Subject: **Response to NCDWR On Hold Letter dated May 9, 2019** for the extension and relocation of NC 84 from NC 16 to SR 1008 (Waxhaw-Indian Trail Road) in Union County. Federal Aid Project No. STP-1316(10), WBS 39019.1.1, Division 10, TIP No. U-3467.

Reference: 404/401 Individual Permit Application dated February 21, 2019
NCDWR On Hold Letter dated May 9, 2019

**LOCATION: SR 1316 (REA ROAD EXTENSION)
FROM NC 16 TO SR 1008**

DRAINAGE REDLINES
CALYX – 4-22-2019
PM – D. BOCKER
DE – A. THOMPSON

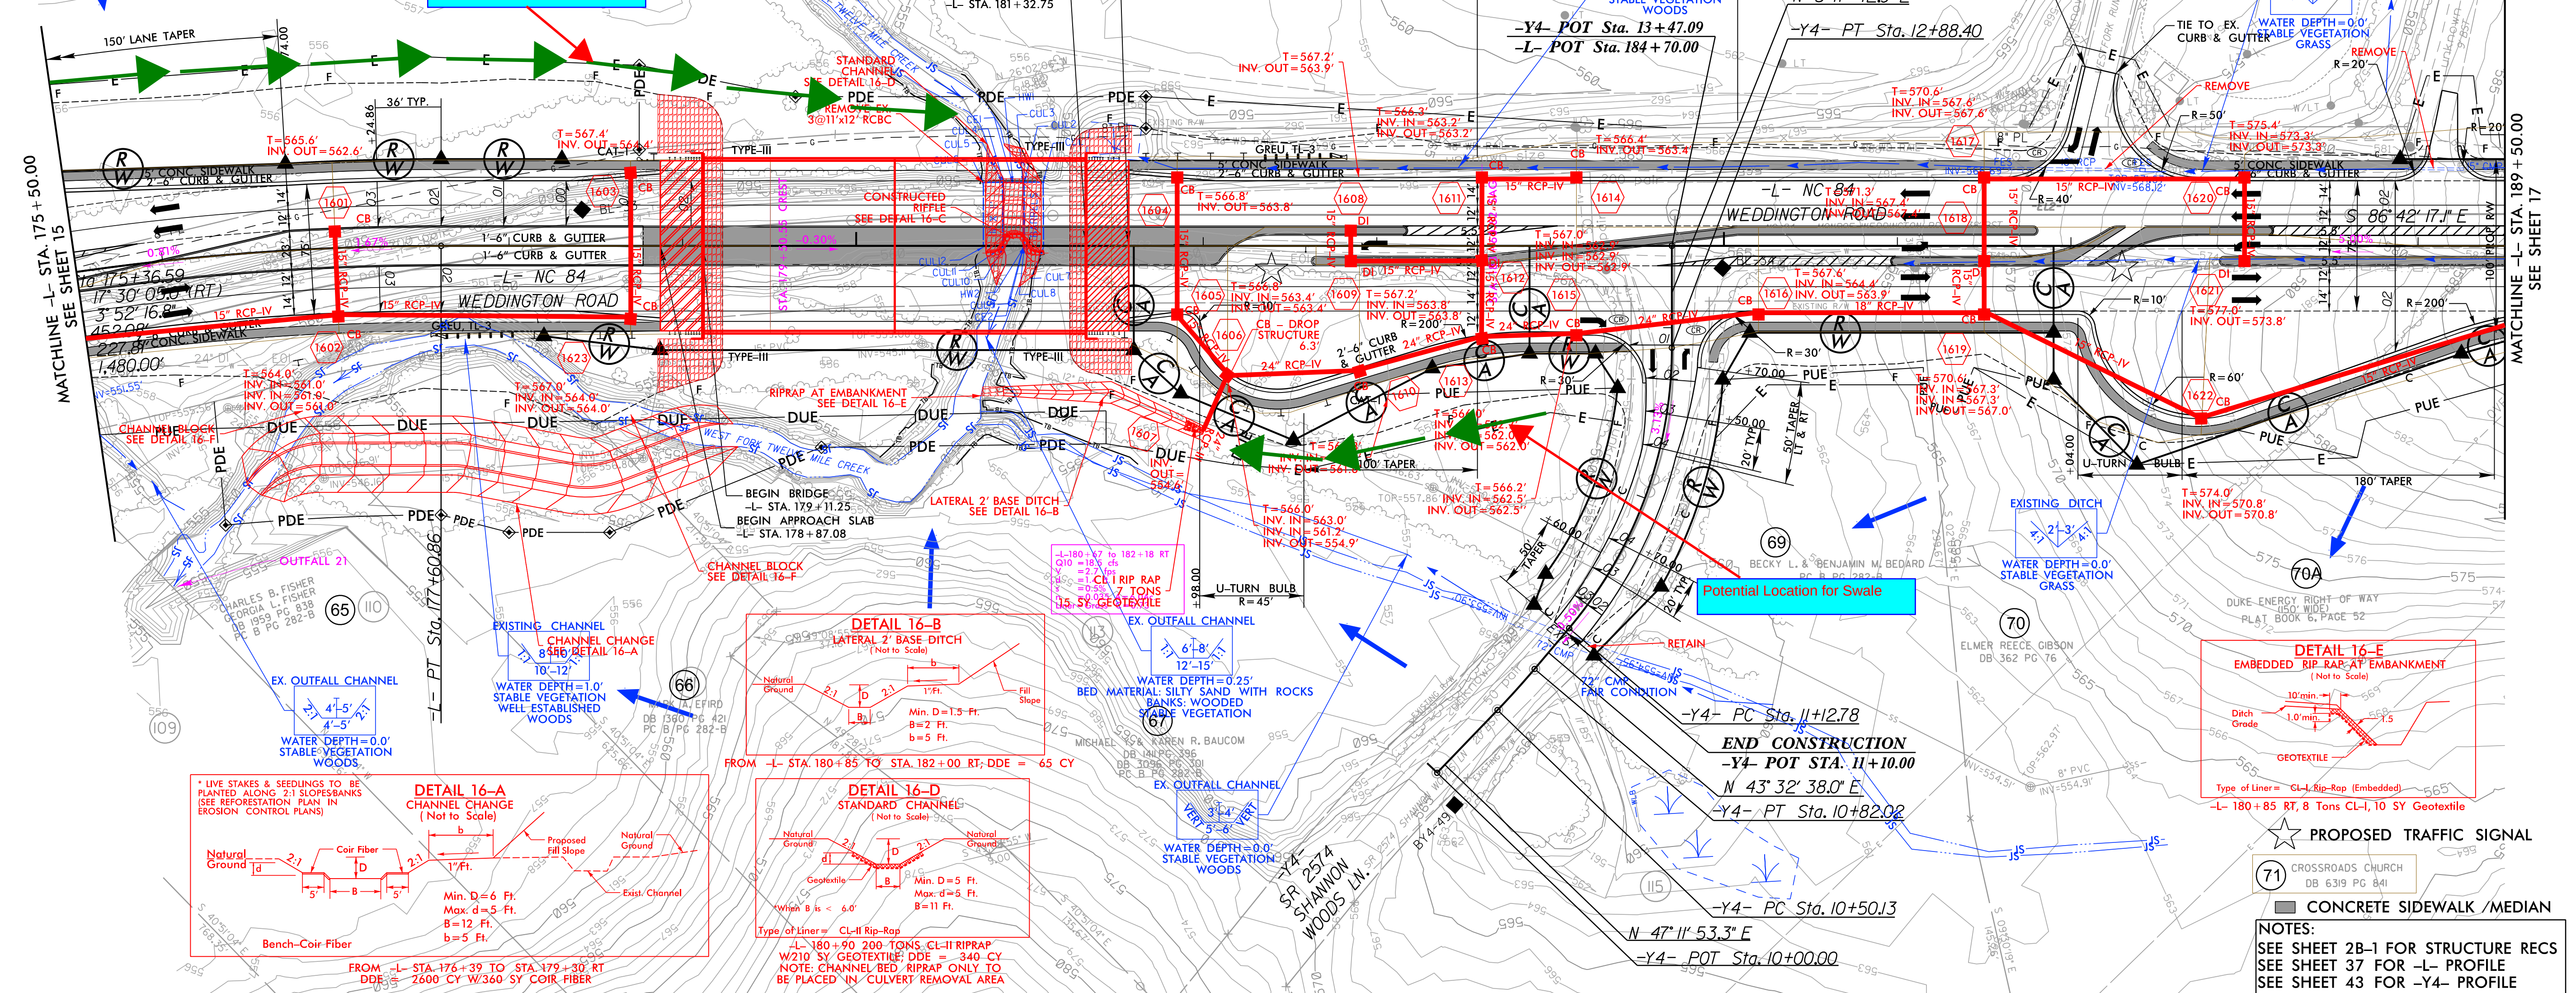
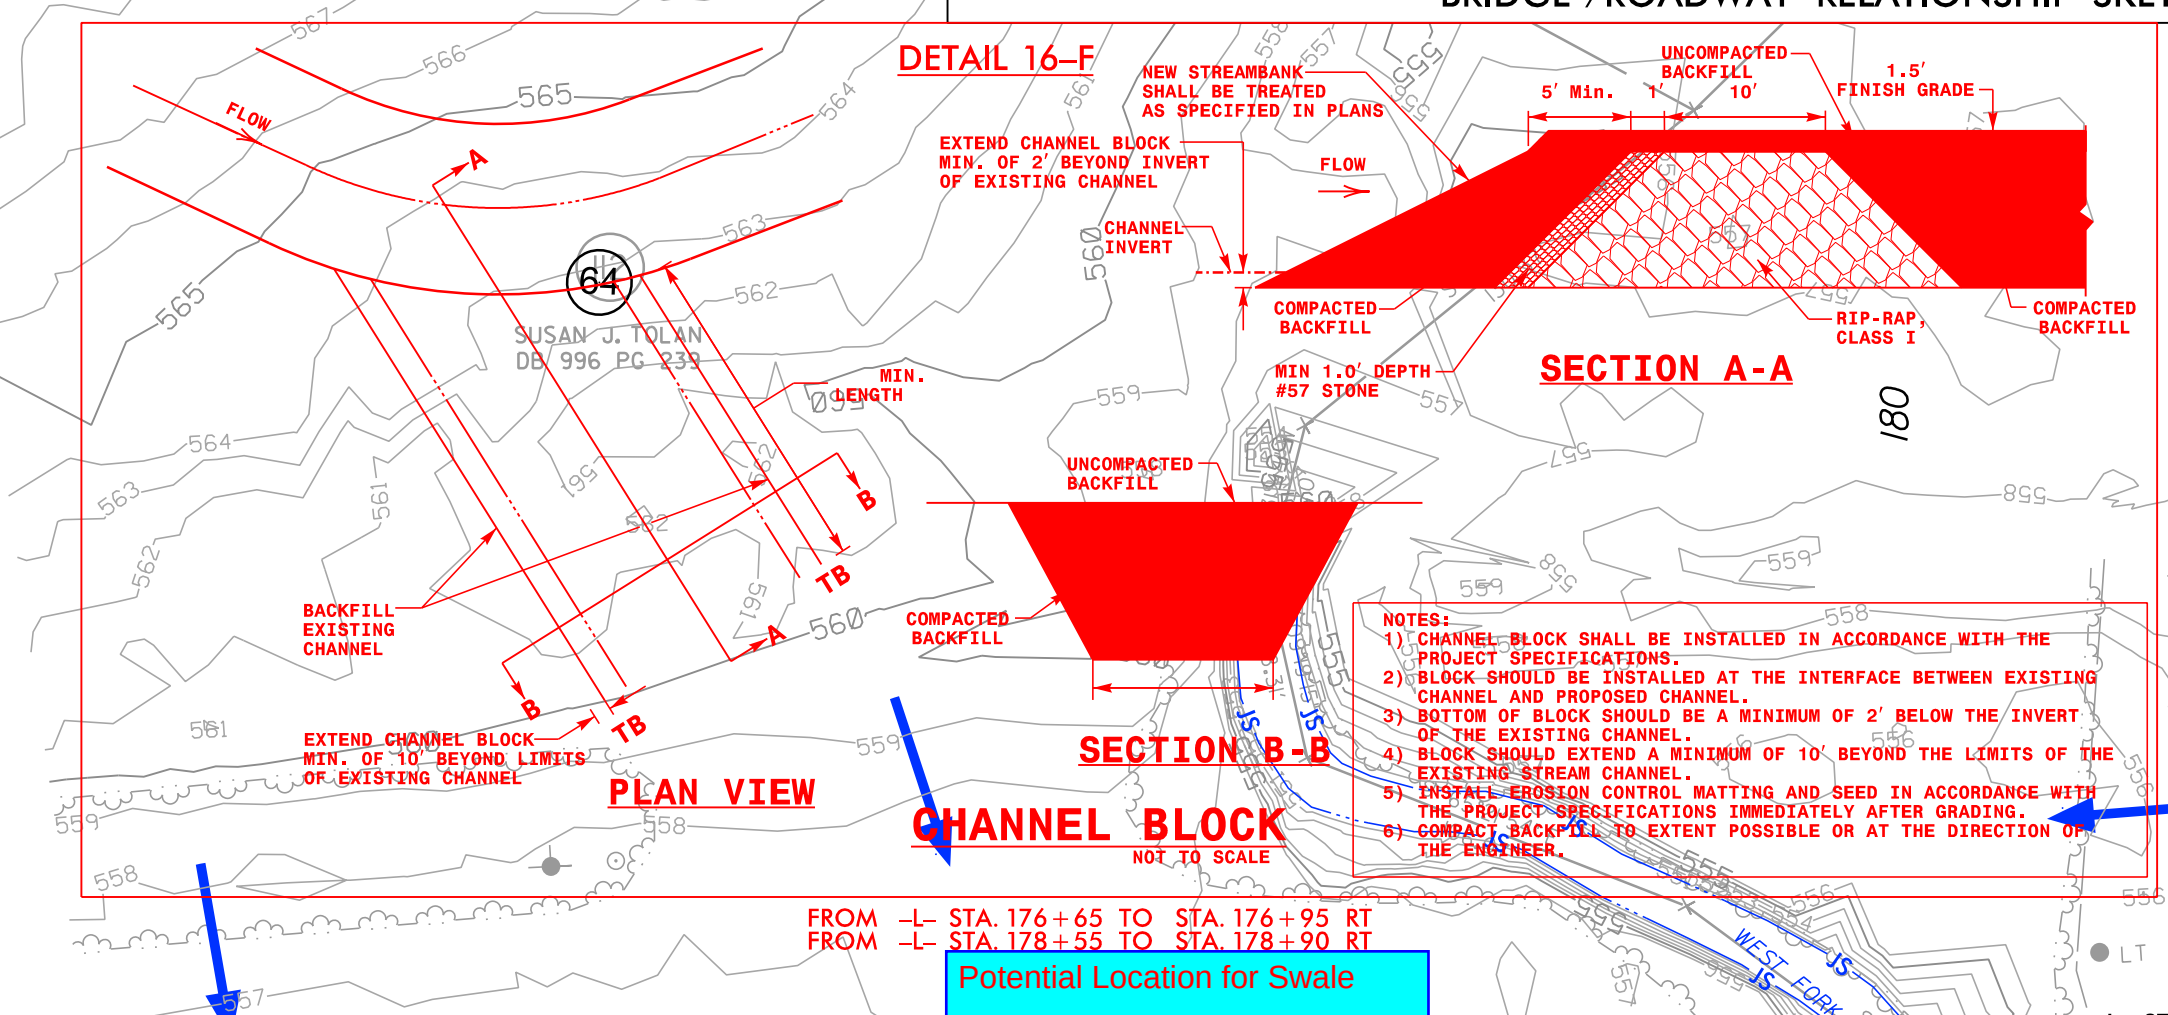
- Plan sheet 15, north and south side: This area has sidewalk curb and gutter. The roadway drainage will be picked up by the proposed storm drain system. A grass swale would not provide any treatment of the roadway drainage in this area.

PROJECT REFERENCE NO.		SHEET NO.
U-3467		18
RW SHEET NO.		HYDRAULICS ENGINEER
ROADWAY DESIGN ENGINEER		
DOCUMENT NOT CONSIDERED FINAL UNLESS ALL SIGNATURES COMPLETED

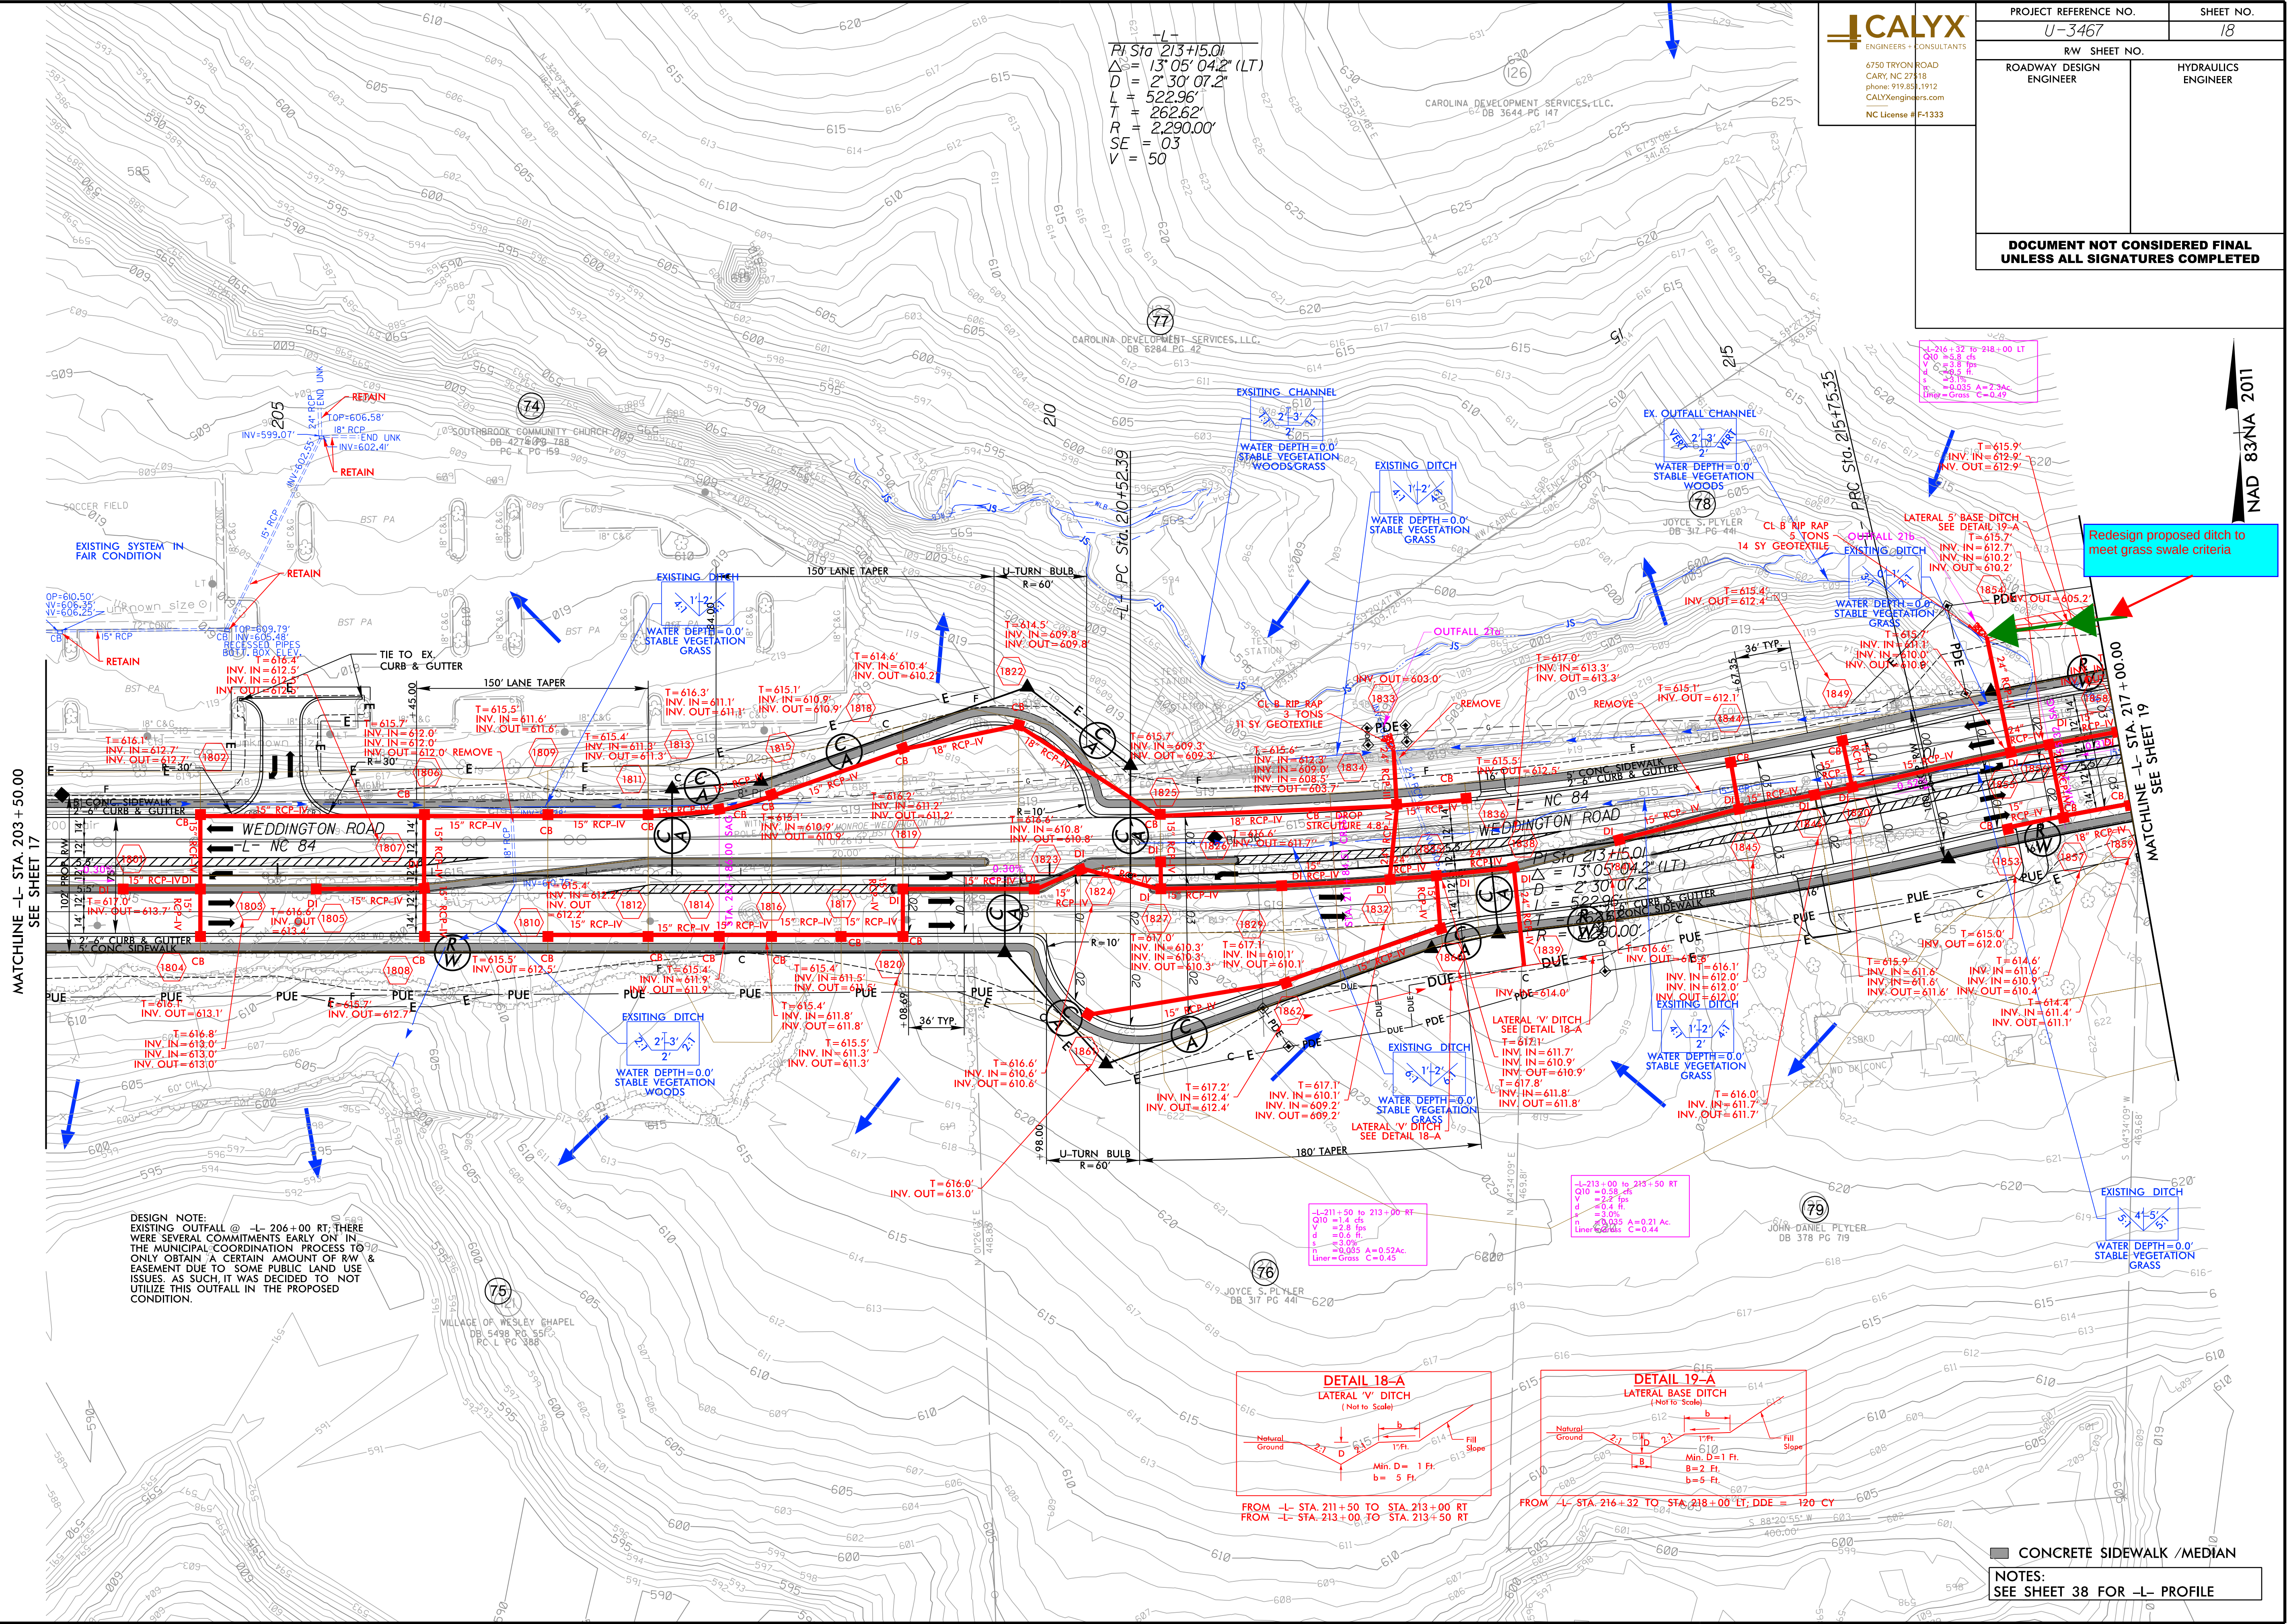
- Plan sheet 18/19: The currently proposed cut ditch has a steep slope (2.5% to 3.1%). To meet swale criteria, there is a potential for major impacts to the currently proposed ROW.

PROJECT REFERENCE NO.		SHEET NO.
U-3467		19
RW SHEET NO.		
ROADWAY DESIGN ENGINEER		HYDRAULICS ENGINEER
DOCUMENT NOT CONSIDERED FINAL UNLESS ALL SIGNATURES COMPLETED

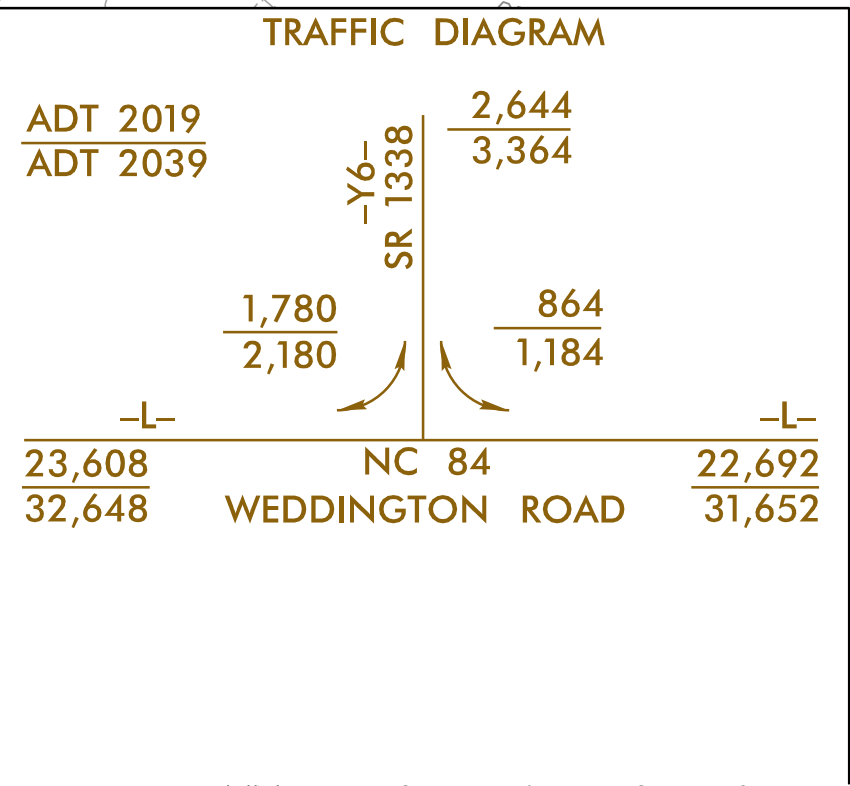
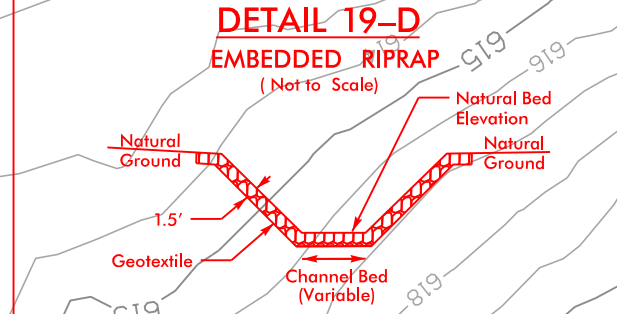
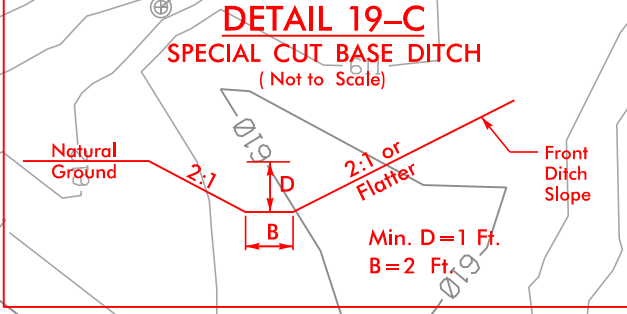
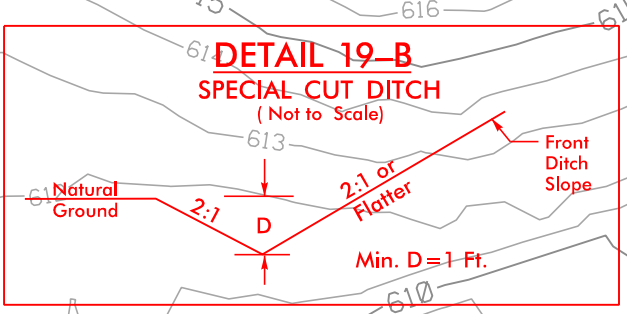
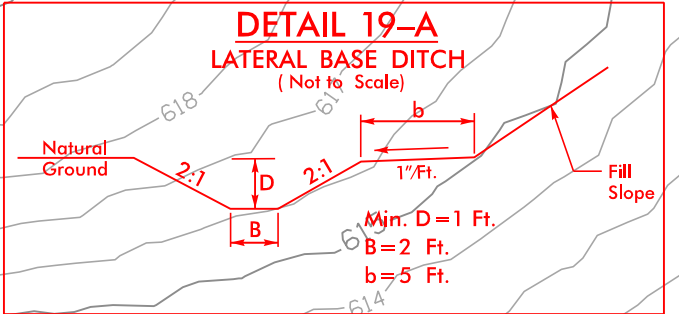
Redesign proposed ditch to
meet grass swale criteria

Revise Design to outlet a
portion of system to the RT /
Potential Location for Swale
